SOUTHERN SANDOVAL COUNTY ARROYO FLOOD CONTROL AUTHORITY

IFB# 2020-03 – UPPER BOSQUE DE BERNALILLO FLOOD MITIGATION PROJECT

ADDENDUM #2

July 10, 2020

SHEET 7 OF 14

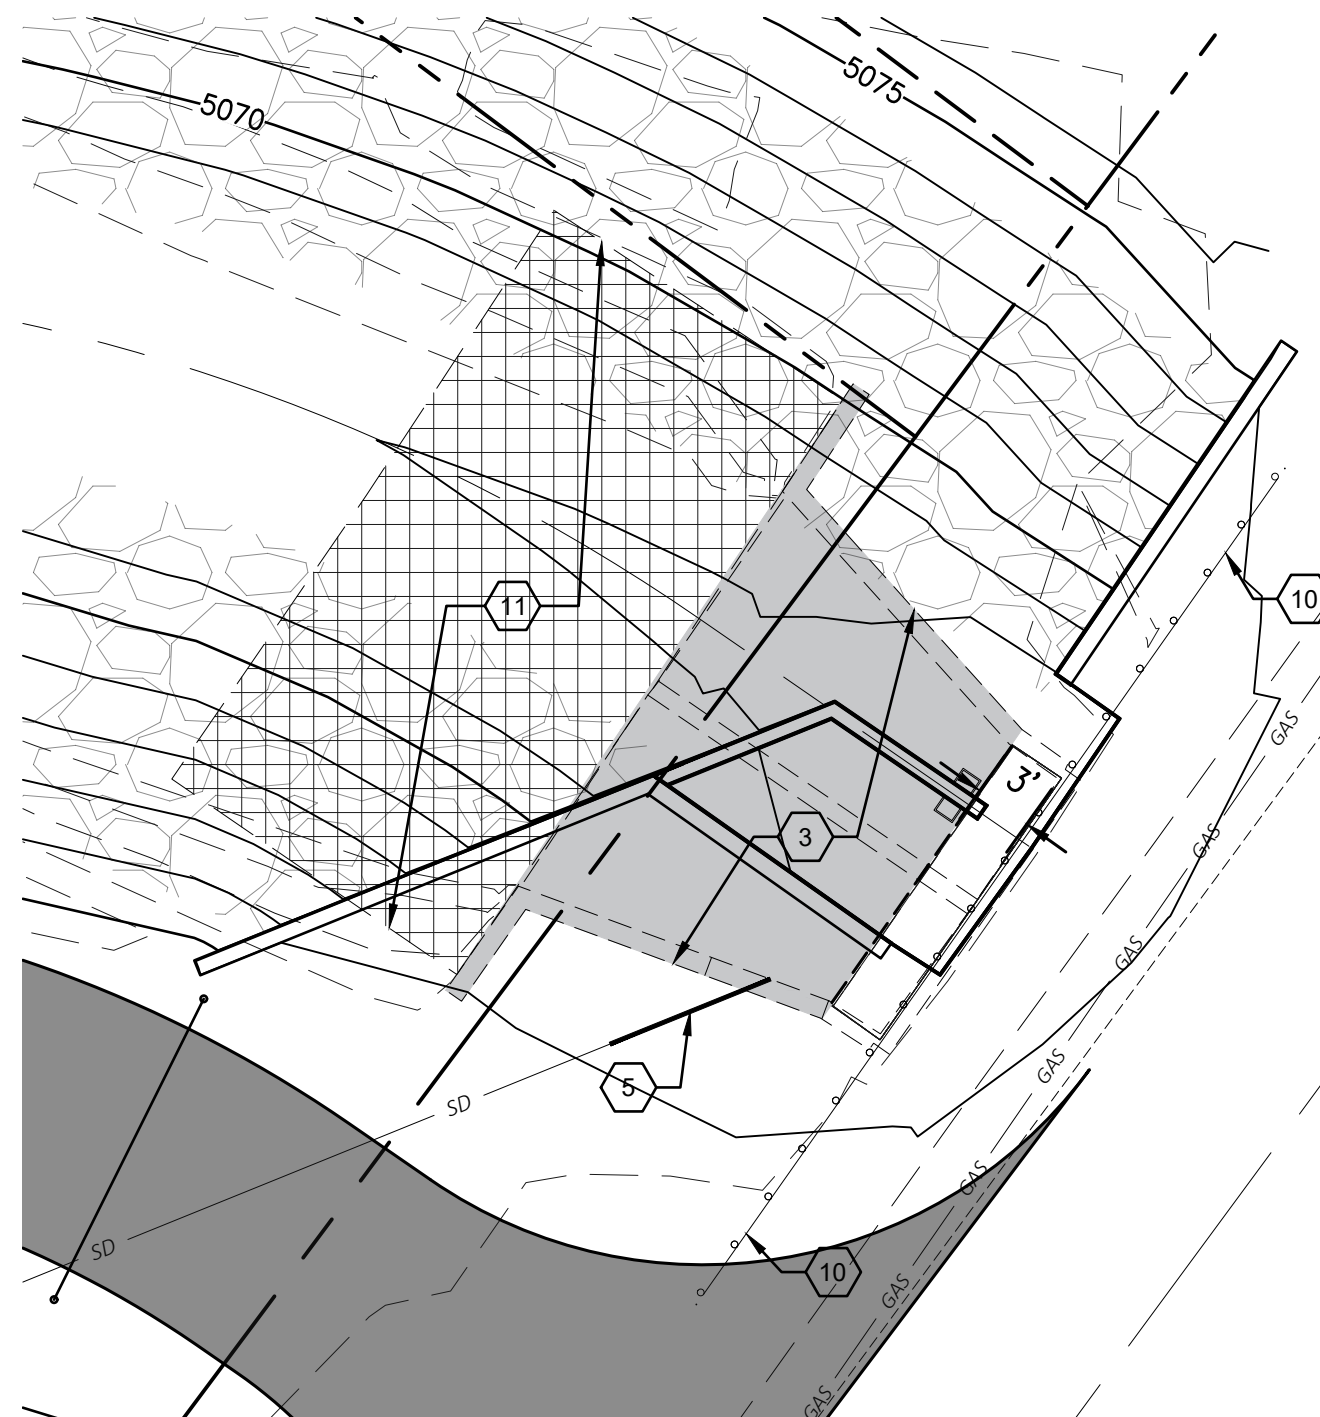
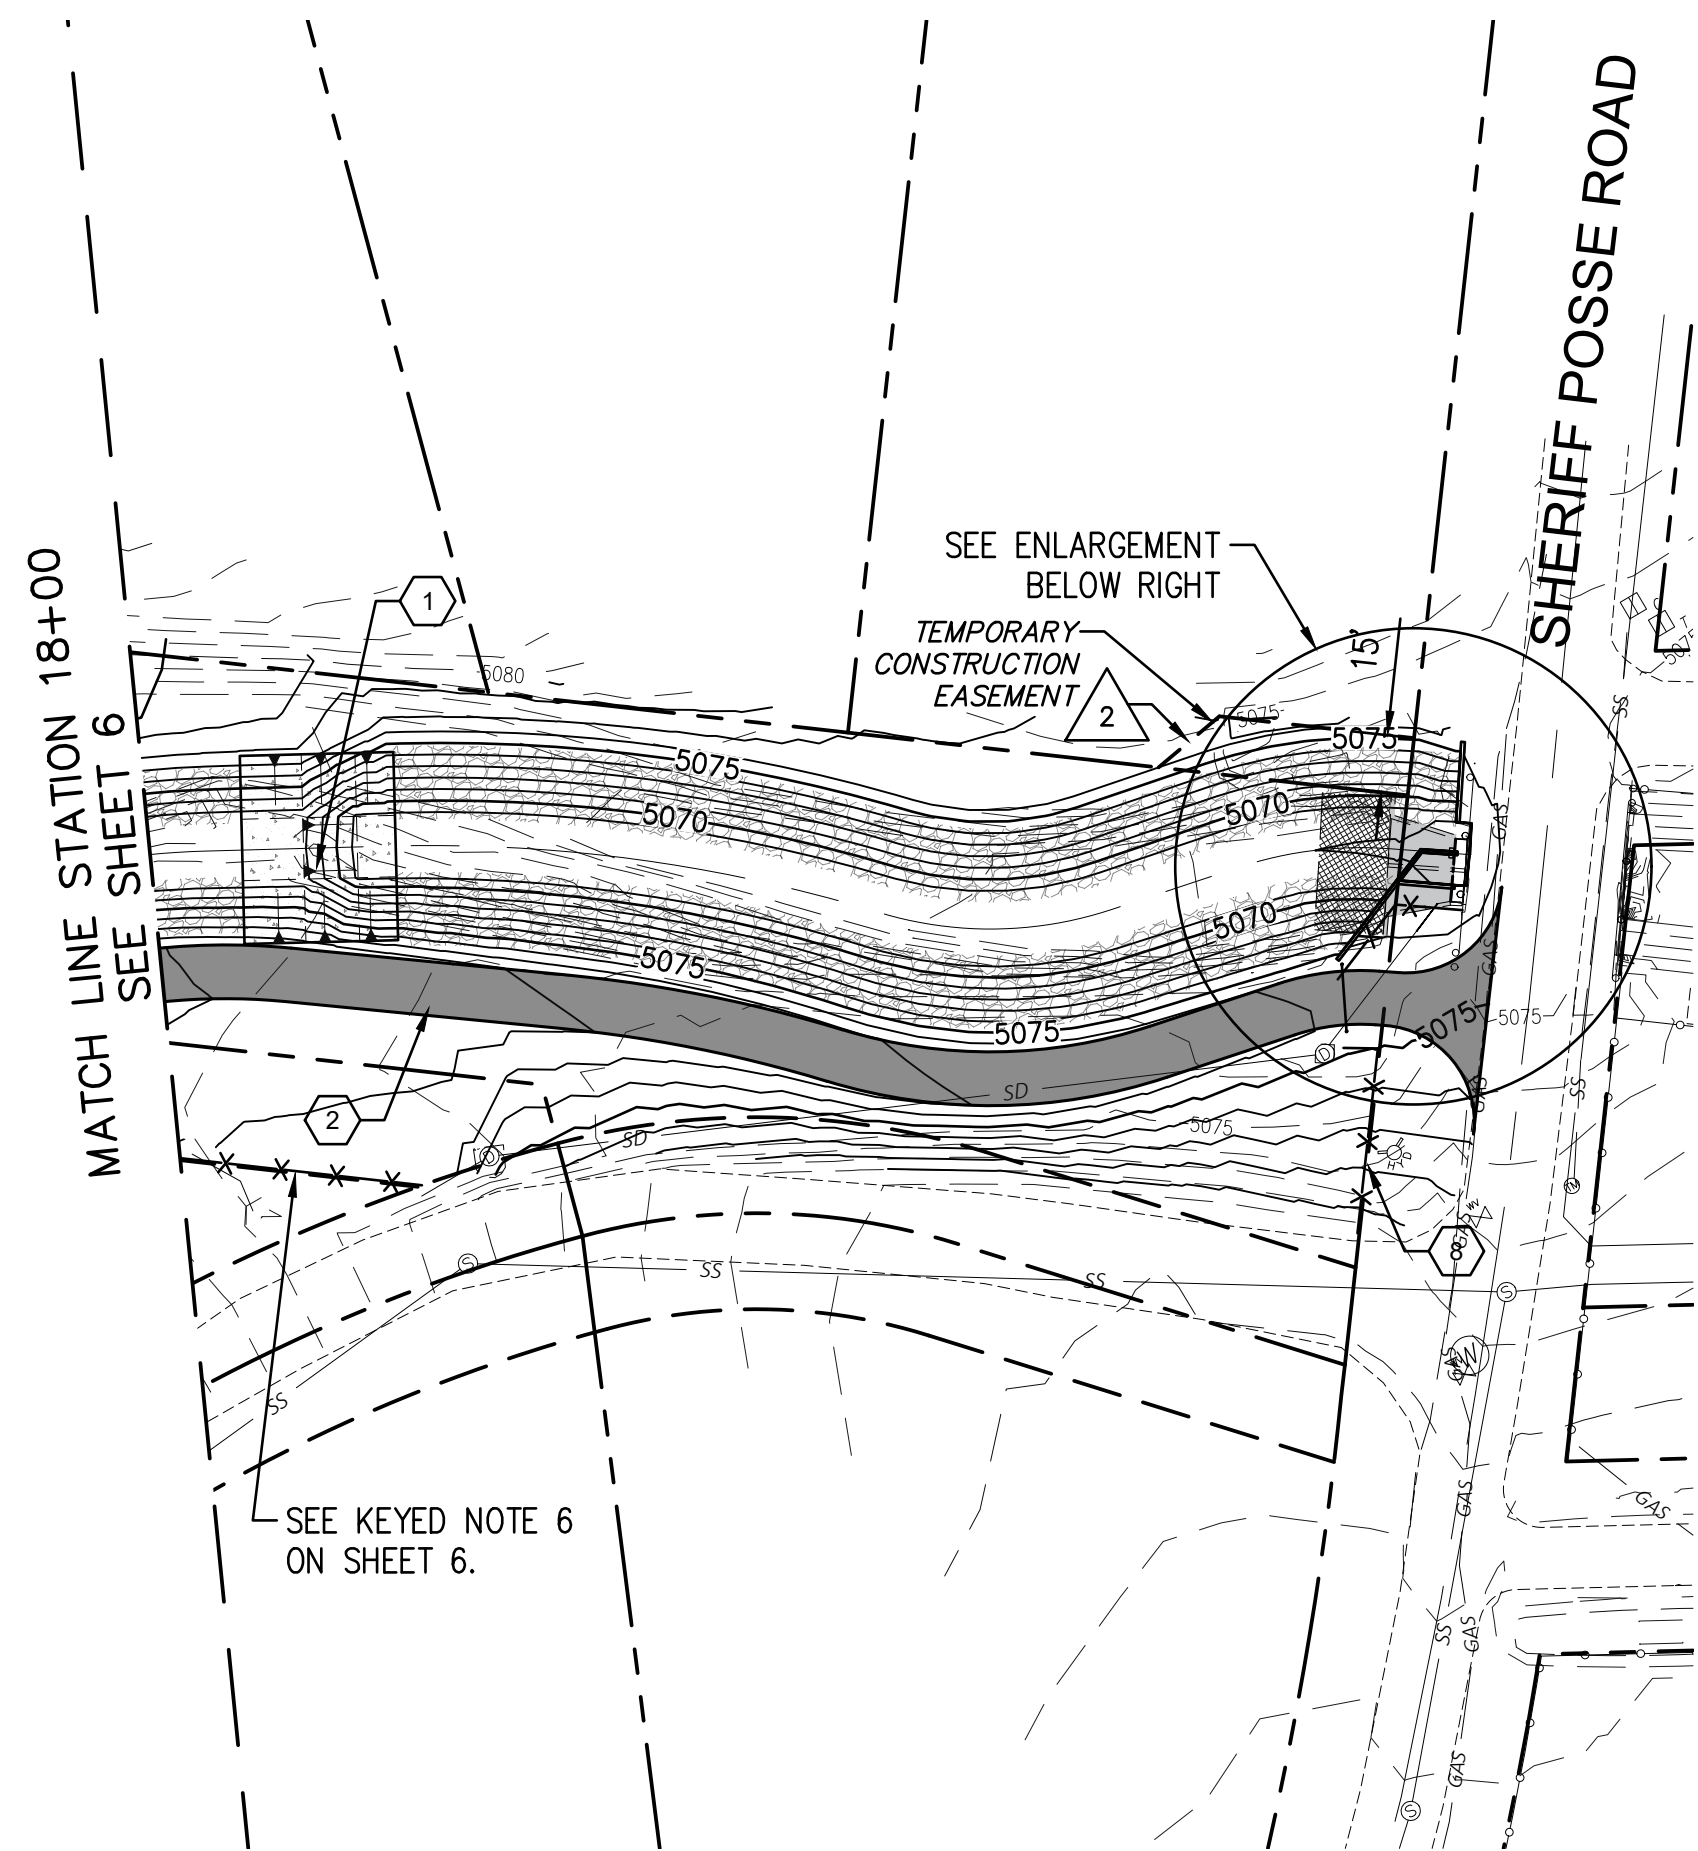
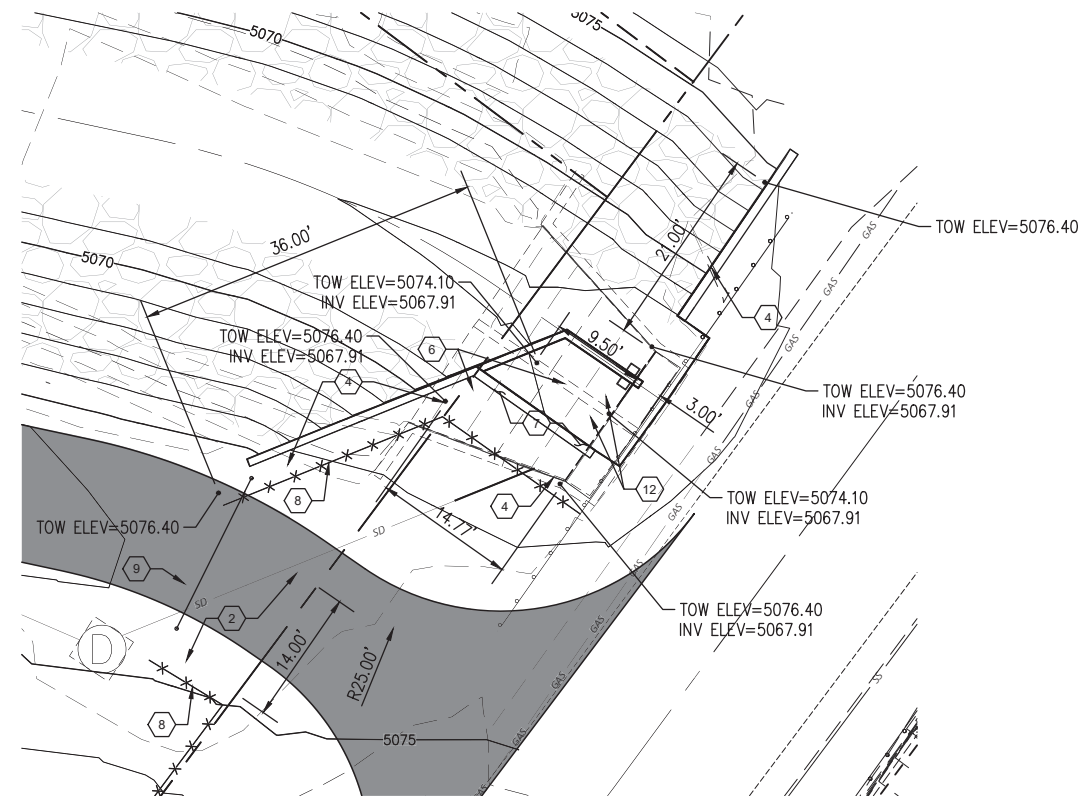
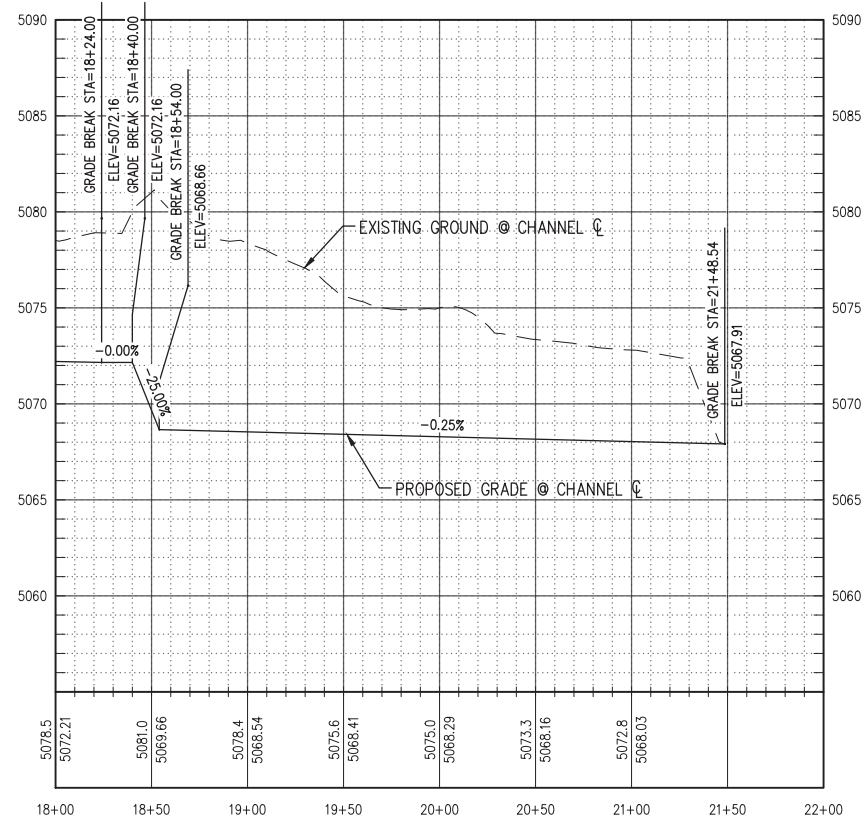
- Replace “Sheet 7 of 14” of the Construction Plans with the attached revised Sheet 7, which revises the Temporary Construction Easement boundary for the lot near the existing CBC. All TCE’s for the project will be strictly enforced.
- Bid Form, Page 20 – Revision of language in 7.01.F. This revision is intended to clarify the title of the required form.
- Unit Price Bid Proposal – Replace Unit Price Bid Proposal Pages 23 & 24 with the attached revised version. This revision included addition of a new Bid Item for Guardrail Removal & Replacement.

REVISIONS & CHANGE NOTICES		
MARK	DESCRIPTION	DATE
2	REVISED TEMPORARY CONSTRUCTION EASEMENT.	7/07/20
